FedEx Ground
Grove City, OH

CY15 OFFICE RENOVATIONS AND PARKING IMPROVEMENTS

RE: Review Letter for FedEx Development Plan

Staff has reviewed your development plan application for the FedEx Ground Office and Parking Improvements located at 6120 South Meadows Drive. The control number for this application is #201602120011 and should be referenced on any future correspondence concerning this matter. Having compiled the comments/recommendations provided to the Development Department from our various departments, we request the following additional information and/or corrections: Development Department (Kimberly Shields, 614-277-3007)

DE GATE (W/O PICKETS)

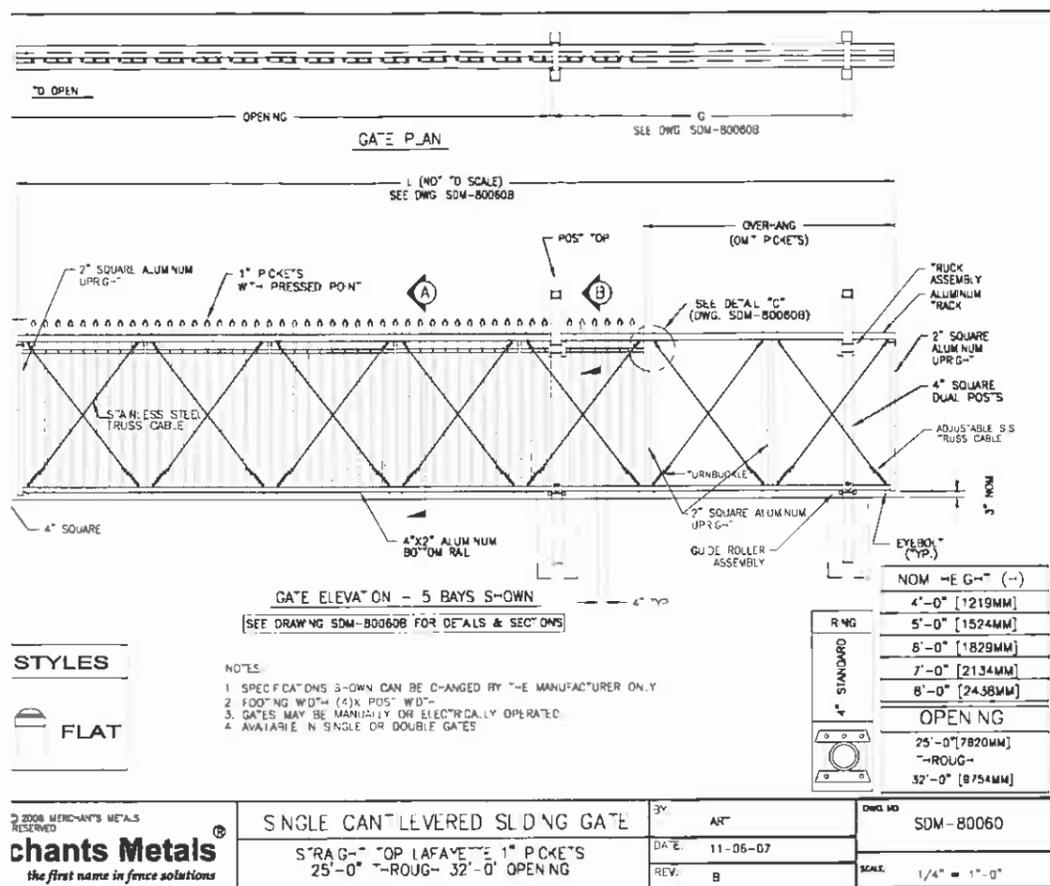
7. Staff is not supportive of the proposed truss gates to access the lots off Seeds Road and believes that a more visually appealing gate should be used (similar to image below).

Response: The security gates for the two Seeds Road entrances has been changed to an ornamental slide gate that will match the existing black ornamental fencing surrounding the northwest parking lot.

NORTHWEST AND NORTHEAST TRUCK PARKING
SCALE 1" = 40'

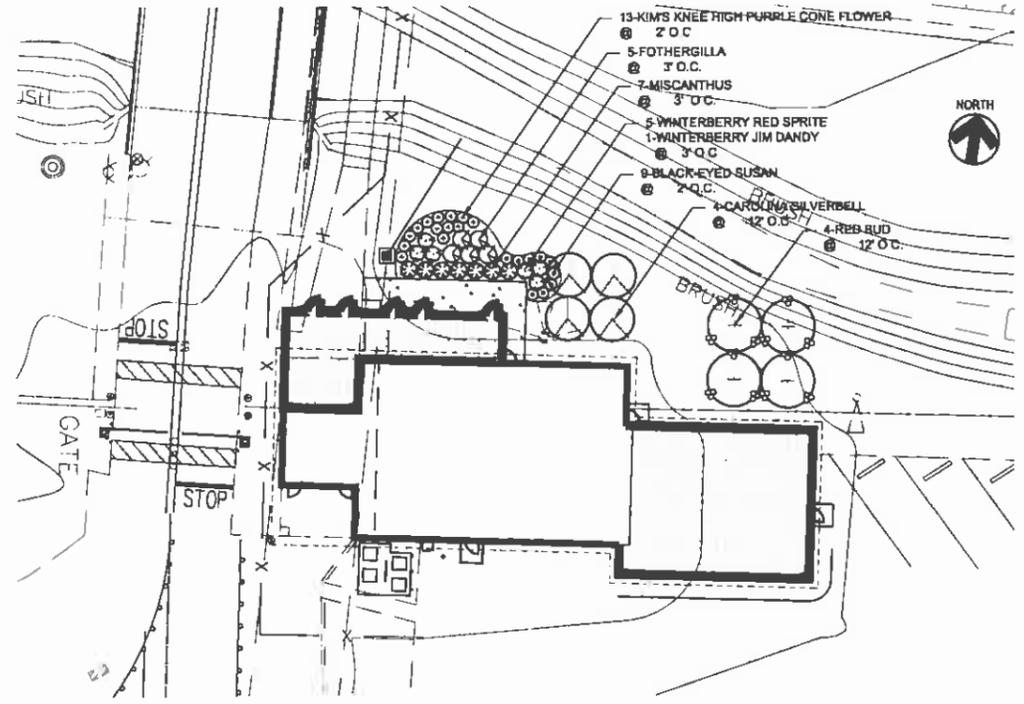
1. The proposed mounding should be extended around the northwest corner of the northwest parking lot (PID 040-004963) to screen the lot from view along London-Groveport Road.

5. Additional landscaping should be installed between Seeds Road and the northwest parking lot to compensate for the addition of truck parking to the lot.

Response: Additional mounding and landscaping has been provided at the northwest corner of the northwest parking lot.
2. Additional landscaping should be installed on the northeast corner of the northeast lot (PID 040-004962) to screen the drive and parking lot from London Groveport Road.

Response: Additional landscaping has been provided along the north side of Seeds road to screen the northwest parking lot.
